**CENTER FOR DRUG EVALUATION AND
RESEARCH**

210136Orig1s000

MEETING MINUTES

Meeting Type: Type B
Meeting Category: Pre-NDA

Figure 3: Urine Toxicology Test Results

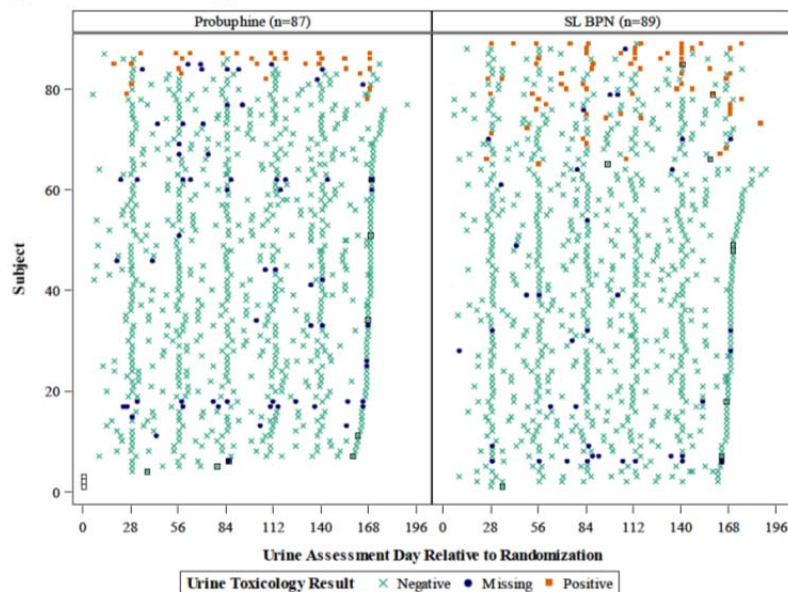
14. Provide a graphical display of subject-level urine toxicology data where urine test results are considered as negative, positive or missing. An example of this type of graph was presented at the Advisory Committee Meeting held on January 12, 2016, for Probuphine.

The Sponsor provided an example graphic display (Slide 7, attachment) for comment, offering two potential approaches. The Division concurred that a presentation that allows differentiation of the individual lines of data is preferable, but recommended that the data be sorted by time to discontinuation, rather than by patient number.
